URGENT FIELD SAFETY NOTICE

GEHC Ref# 32067

RE: Giraffe Bedded Warmer/Panda iRes Warmer - Bedside panels, latch areas may be cracked, broken or damaged.

Figure 1A: Bedside panels

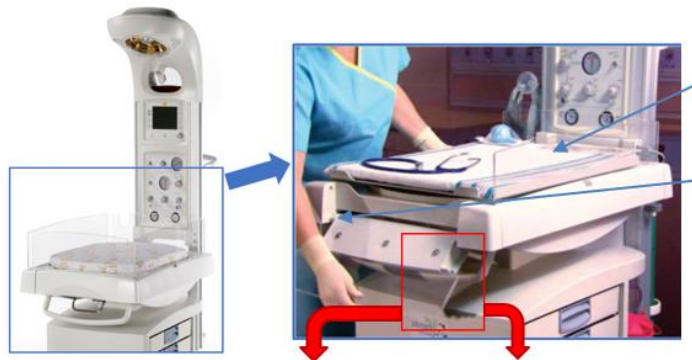
GE Healthcare has become aware that the bedside panels, and latch areas on the warmer can crack or break if the unit is moved using the bedside panels instead of the front handle or the maneuvering handle. If an infant impacts a bedside panel with a cracked or broken latch, the panel can disengage and fall open, no longer protecting the infant from falling from the warmer.

1) Inspect the warmer bedside panels (see below Figure 1A) latch areas and the areas connecting the panel to the bed (see below Figure 1B) for any cracks or damages per the addendum included in this mailing. **If any portion of the bedside panels or latches are cracked or broken (see below Figure 1C), stop use of the warmer.** Complete and return the attached response form in Table 1-1, indicating what components require replacement. If the Warmer bedside panels or latches (see below Figure 1D) have no cracks or damage, continue to Safety Instruction 2.

GE Healthcare will replace all cracked or damaged bedside panels/latches at no cost to you. Complete and return the attached "Customer Response" form via e-mail to MIC.Recall@ge.com and a GE Representative contact you to arrange for a replacement.
